LEE'S SUMMIT MISSOURI®

Development Services Staff Report

File Number	PL2024-319
File Name	PRELIMINARY DEVELOPMENT PLAN – 150 & Ward Apartments
Applicant	Milhaus
Property Address	3620 SW Ward Rd.
Planning Commission Date	April 24, 2025
Heard by	Planning Commission and City Council
Analyst	Adair Bright, AICP, Senior Planner

Figure 7 – Typical “Building A” (side elevation)

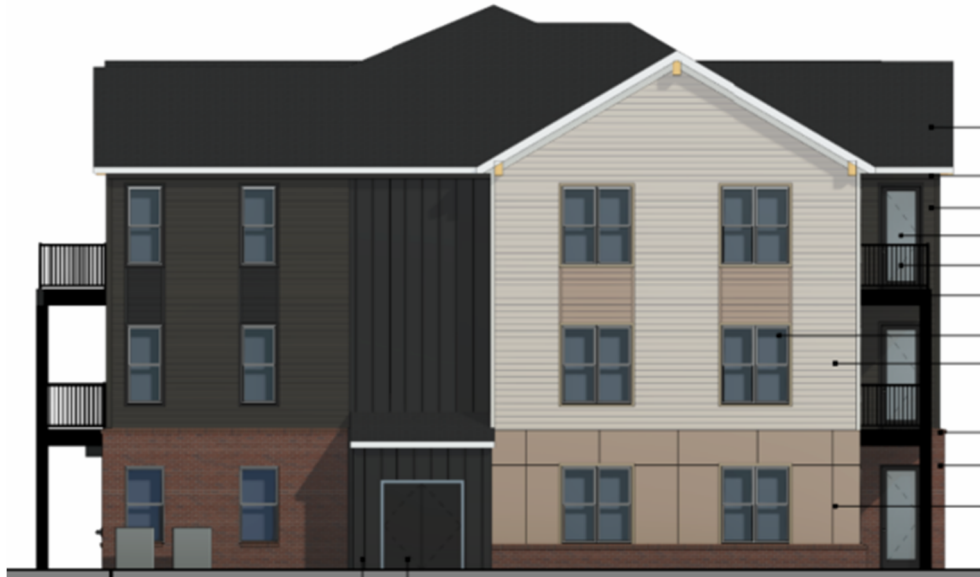
4. The applicant has requested a modification to UDO Sec. 5.510.B.4.c(6) pertaining to building design as required by the M-150 CDO. Staff has reviewed the request and supports the modification for the reasons identified below.

- **Requirement** – At least 20 percent of all walls facing a public street shall contain windows or doorways.
 - **Proposed** – Due to the orientation of the buildings and the site having a street on three out of the four sides, the side elevations of building types A, B, and C will face the street and have less than 20% windows or doorways.

- **Staff Recommendation** – Staff is supportive of the proposed modification since the intent is to ensure street-facing facades include a mix of materials and variation. The street facing facades use five different materials including the windows and doorways. On average, the street-facing facades of buildings A, B, and C will have 11%-17% containing windows or doorways.

4. A modification shall be granted to UDO Sec. 5.510.B.4.c(6) to reduce the required percent of windows or doorways on walls facing a public street from 20% to 11% for Building Type C and 17% for Building Types A and B.

Figure 8 – Site Plan showing property lines and existing right-of-way (property line shown in thick dashed line)

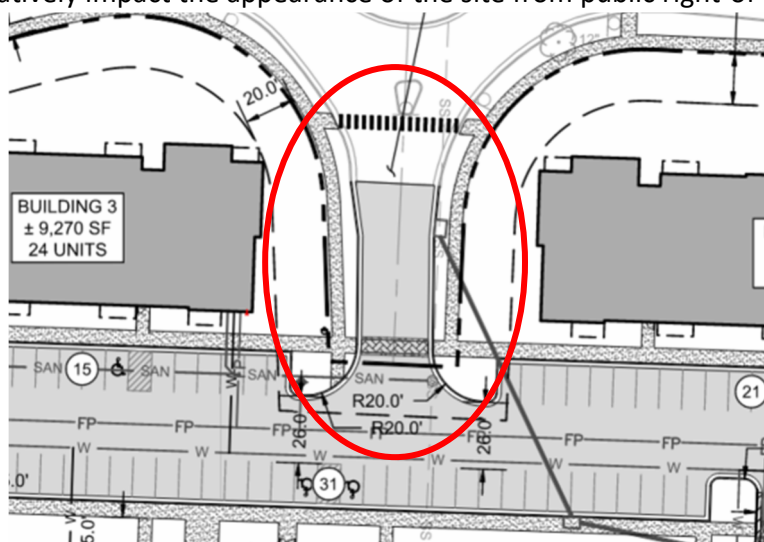
5. The applicant has requested a modification to UDO Sec. 8.620.B.1 pertaining parking lot setbacks. Staff has reviewed the request and supports the modification for the reasons identified below.
- **Requirement** – All parking lots shall be set back a minimum of 20 feet from any public right-of-way or private street edge of pavement.
 - **Proposed** – The applicant is proposing to reduce the parking lot setback adjacent to the right-of-way for the SW Arborwalk Boulevard roundabout from the required 20-ft. to 0-ft.
 - **Staff Recommendation** – Staff is supportive of the proposed modification due to how far the right-of-way cuts into the proposed site. The right-of-way extends 60-ft. south into the site from the edge of pavement of the roundabout. Approval of the modification is not anticipated to negatively impact the appearance of the site from public right-of-way.

5. A modification shall be granted to UDO Sec. 8.620.B.1 to reduce the required parking lot setback adjacent to the right-of-way for the SW Arborwalk Boulevard roundabout from 20-ft. to 0-ft.
